ADDENDUM NO. 2

MLK ELEMENTARY SCHOOL WELLNESS CENTER BAKERSFIELD CITY SCHOOL DISTRICT

Project No.: 5527 DSA File No. 15-6 DSA App No. 03-122605 December 19, 2024

S7.03

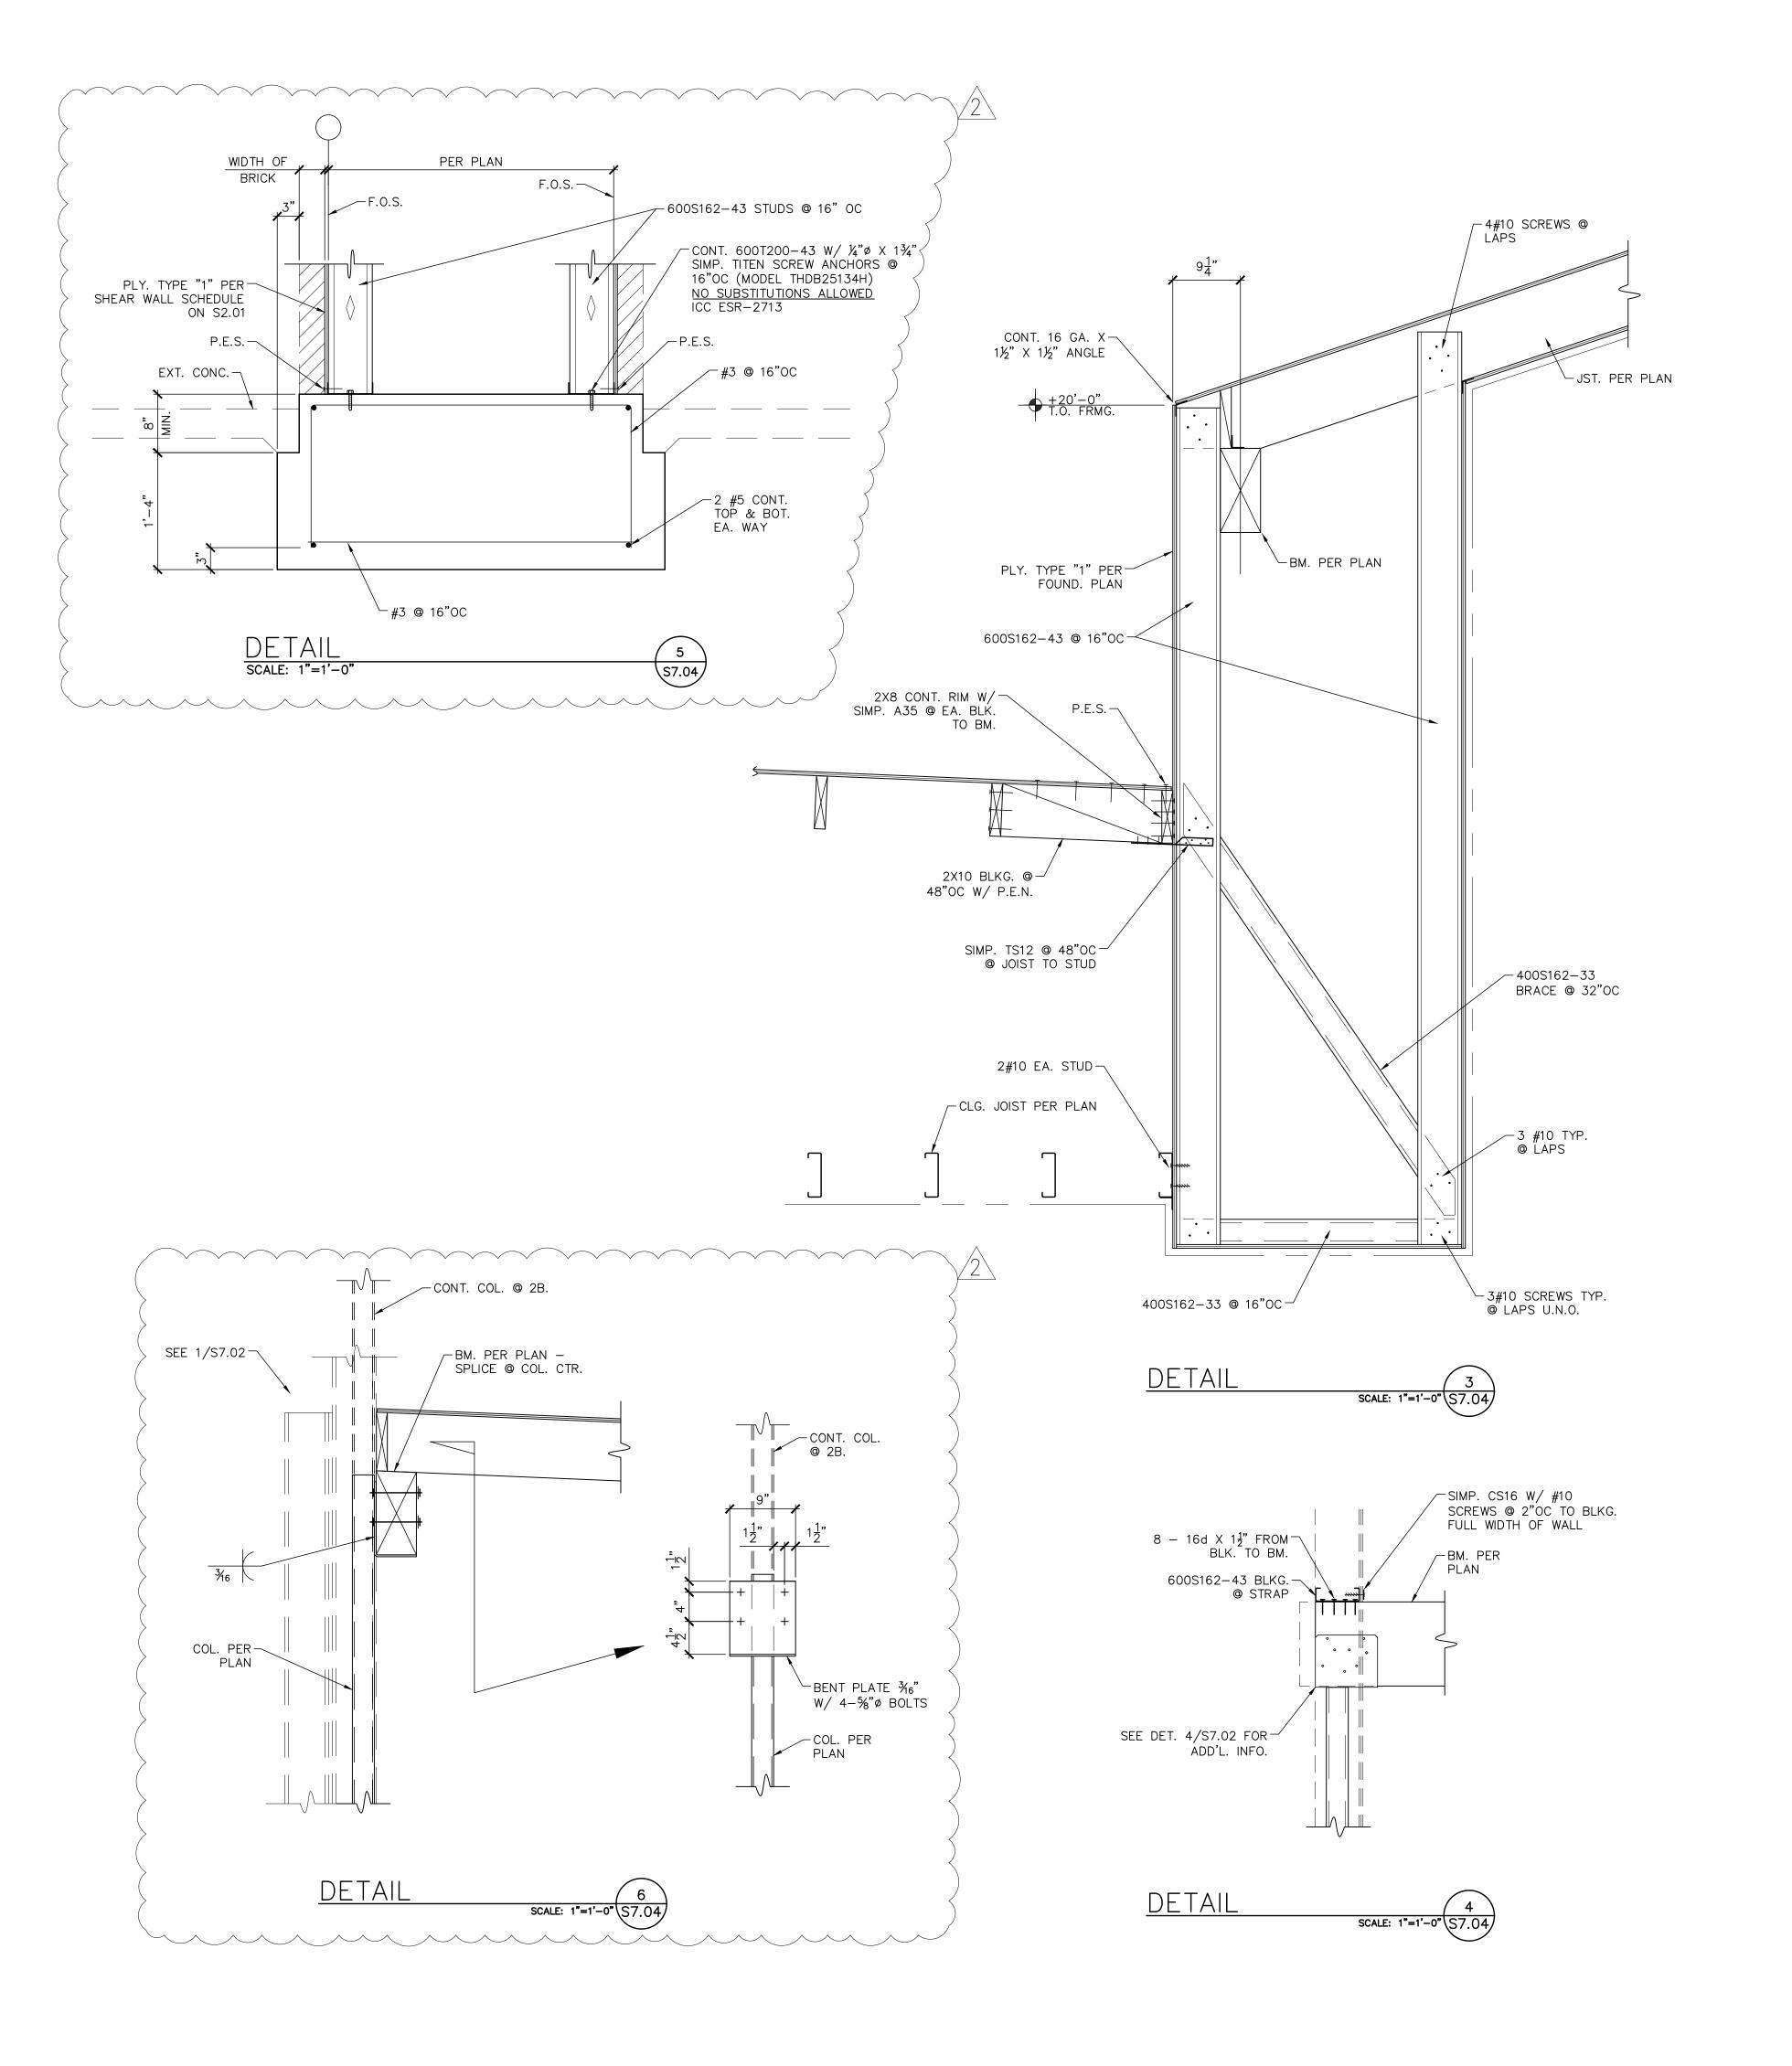
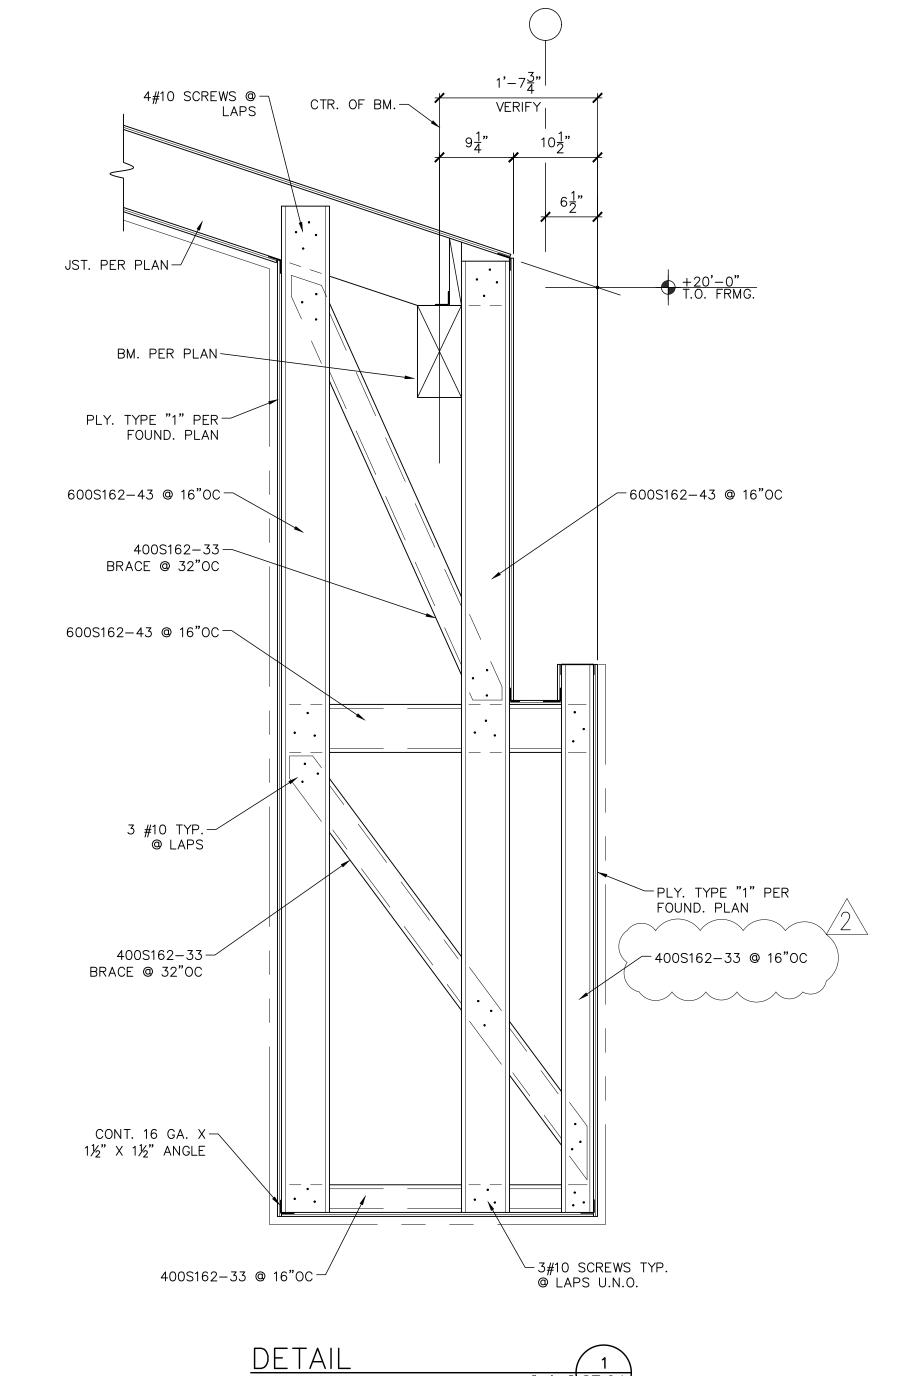
- 1. Detail 2/S7.02 has been added.
 - Detail 1/S7.02 has been modified.
- **2-26 DRAWING, SHEET S7.03 FRAMING DETAILS:** Note the following changes (See detail S7.03 addendum 2 drawings):

- 1. Detail 2, 3 and 5/S7.03 have been modified.
 - 2. Detail 4/S7.03 has been deleted.
- **2-27 DRAWING, SHEET S7.04 FRAMING DETAILS:** Note the following changes (See S7.04 on addendum 2 drawings):

GENERAL NOTES -**LEGEND**

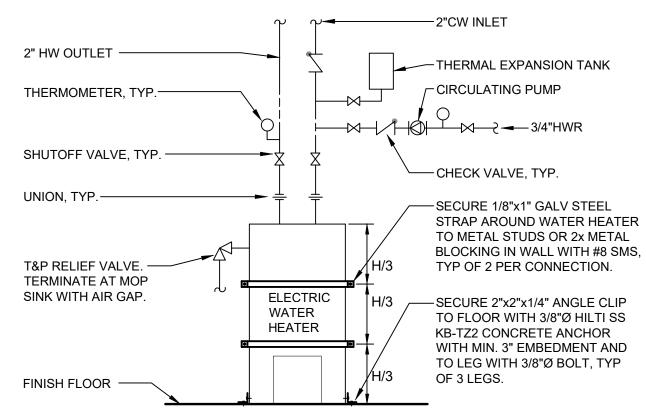
- **2-28 DRAWING, SHEET M0.01 GENERAL NOTES-LEGEND:** Note the following changes (See M0.01 addendum 2 drawing):
 - 1. Add OFCI "Owner Furnished Contractor Installed" to schedules
- **2-29 DRAWING, SHEET M0.11 DETAILS:** Note the following changes (See M0.11 addendum 2 drawing):
 - 1. Add detail 8 and 14/M0.11 in their entirety.

M3.11

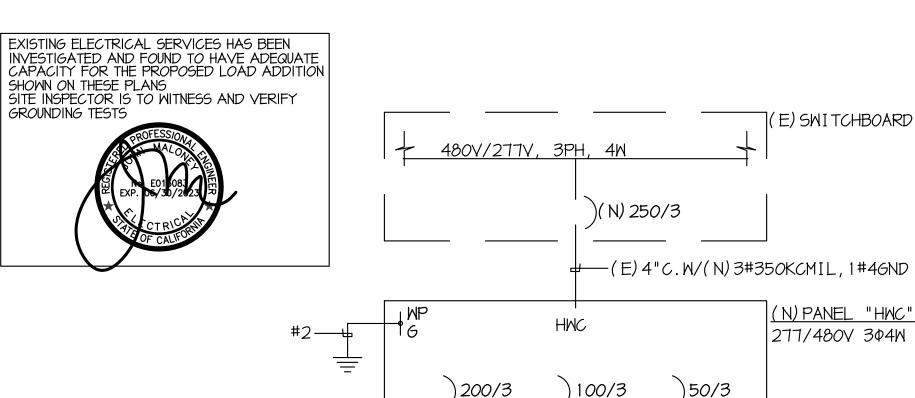
- **2-30 DRAWING, SHEET M2.11 HVAC PLAN:** Note the following changes (See M2.11 Addendum 2 drawing):
 - 1. Change location of wireless repeater in room 122. See keynote 7.
 - 2. Exhaust fans have been modified. See keynote 2.
 - 3. Keynotes 1, 2, 4, 5, 6 and 7 have been modified.
 - 4. Legend have been added.
- **2-31 DRAWING, SHEET M3.11 PLUMBING PLAN:** Note the following changes (See M3.11 addendum 2 drawing):
 - 1. Condensate lines have been modified. See keynote 17.
 - 2. Keynotes 2 and 17 have been modified.
 - 3. Legend has been added.
